#14 TARBELL AVENUE 352-P-40-41 & 4-5

Memorandum from Department of Building Inspection, Portland, Maine

AP - 14 Tartell Avenue (Assessors' Lot Nos. 332-F-40 & 41)

AP 14 Tarbell Avenue

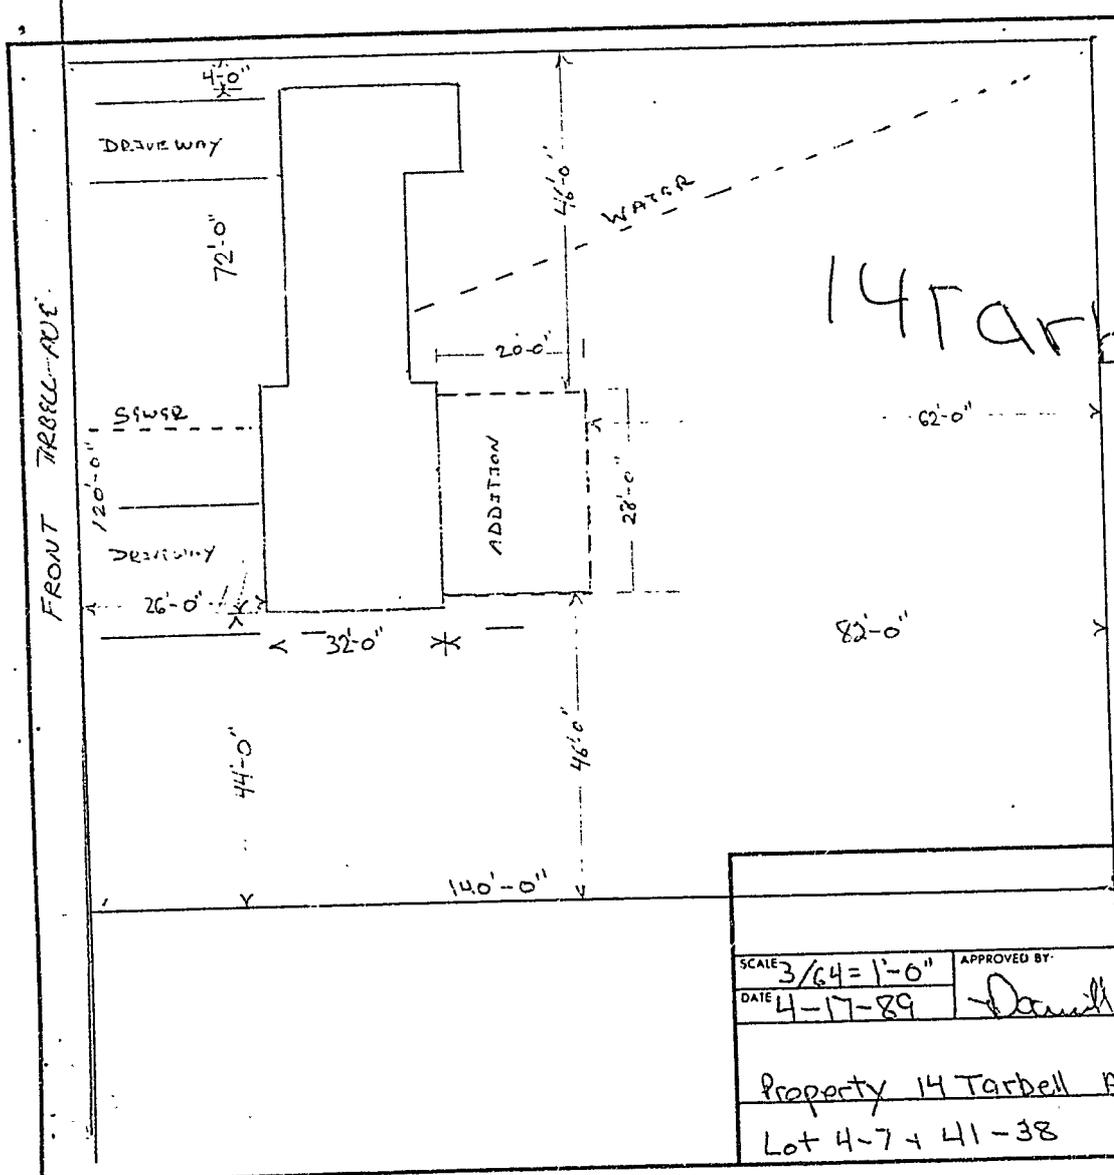
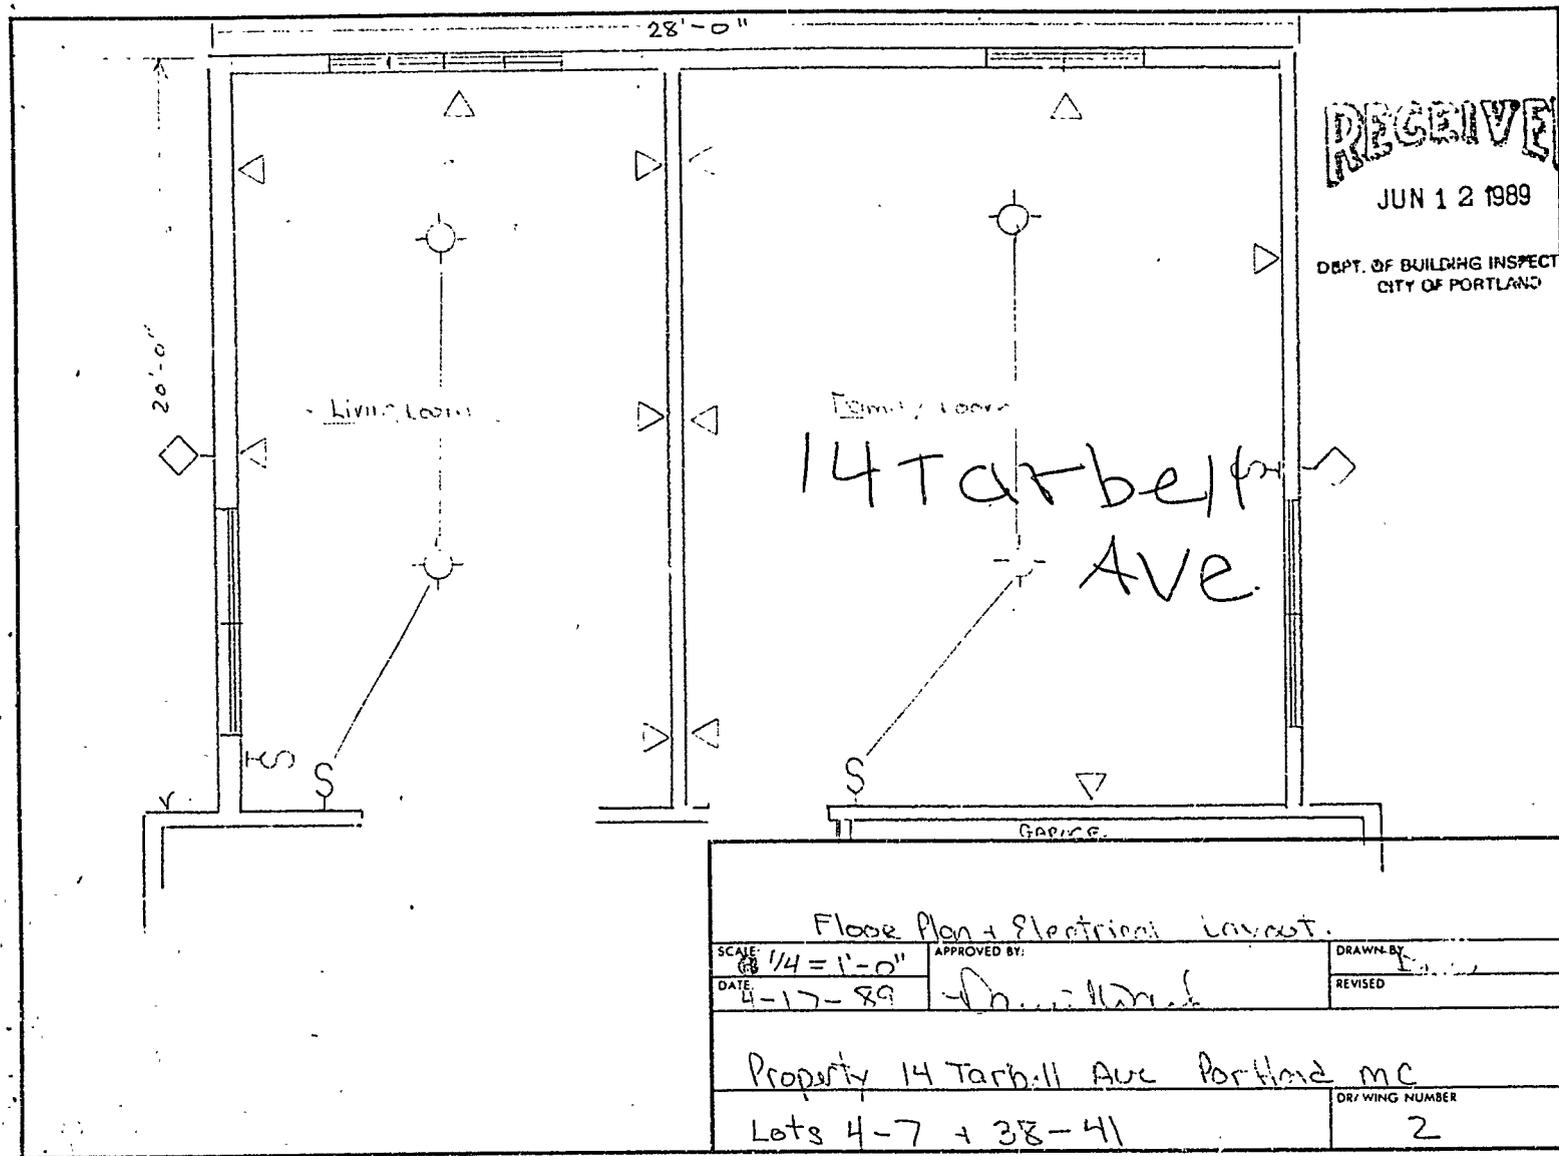
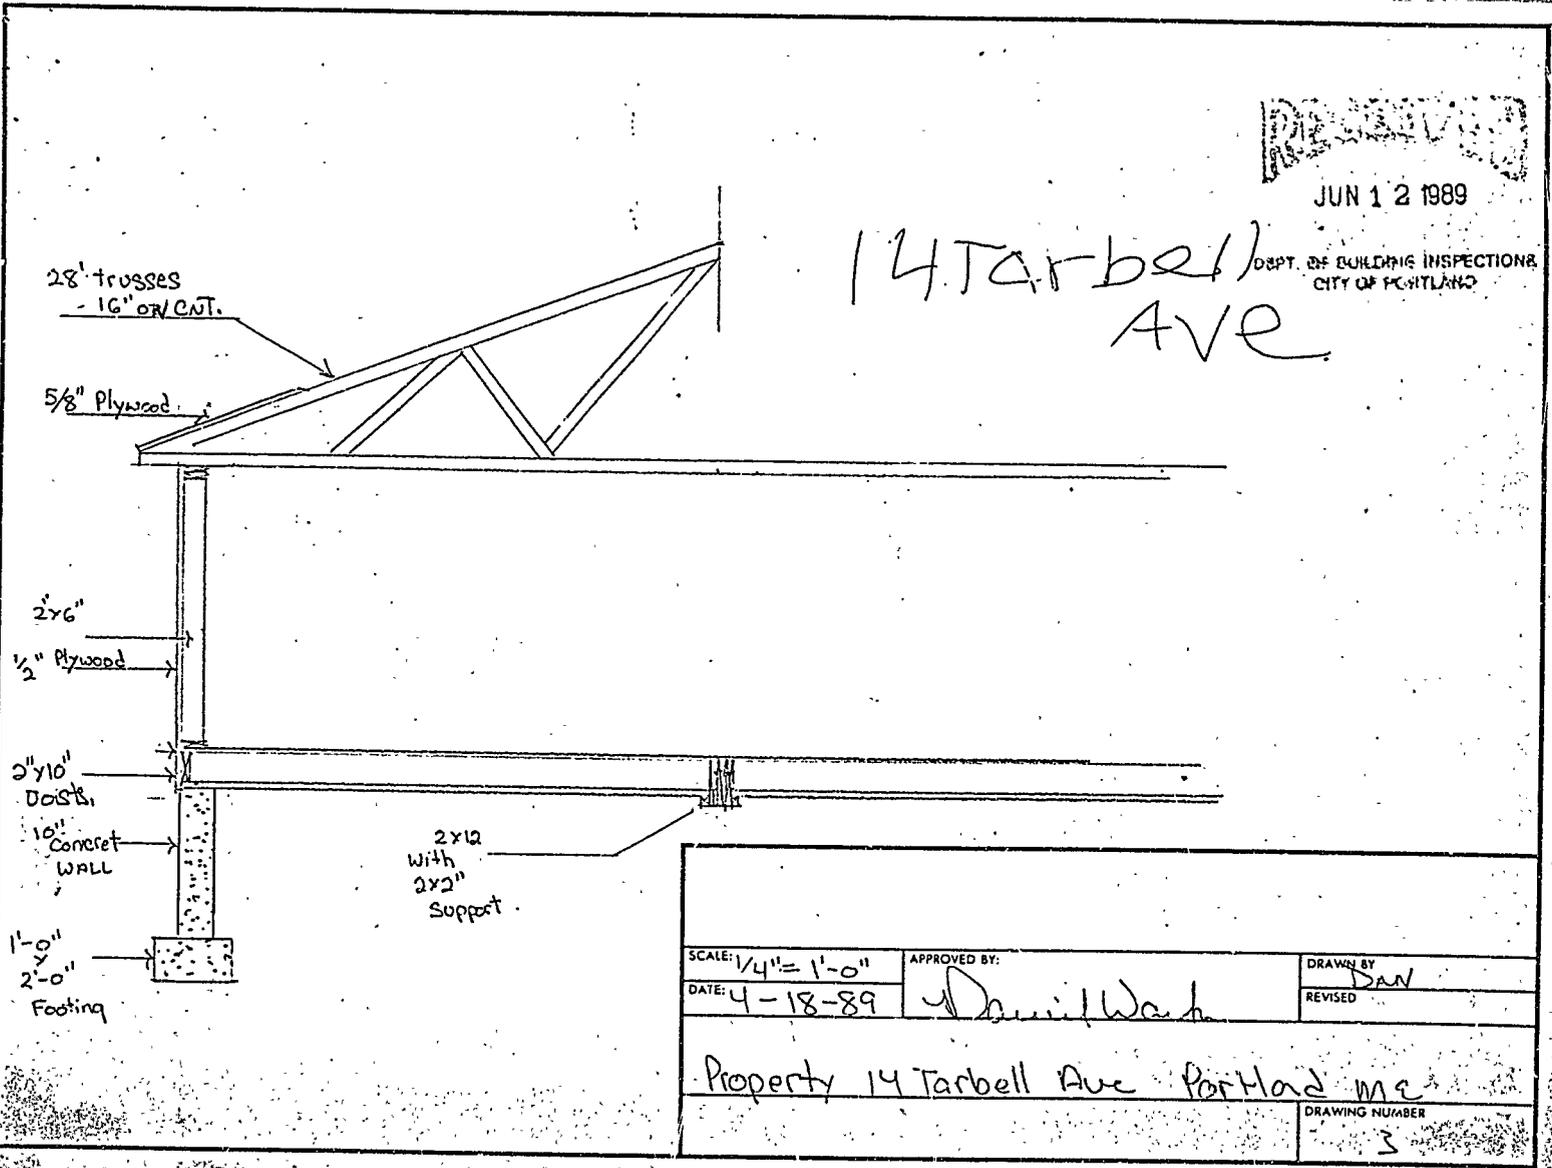
Not using XXXXXX trusses, but rafters instead. Installing bathroom.
1 set of plans submitted.
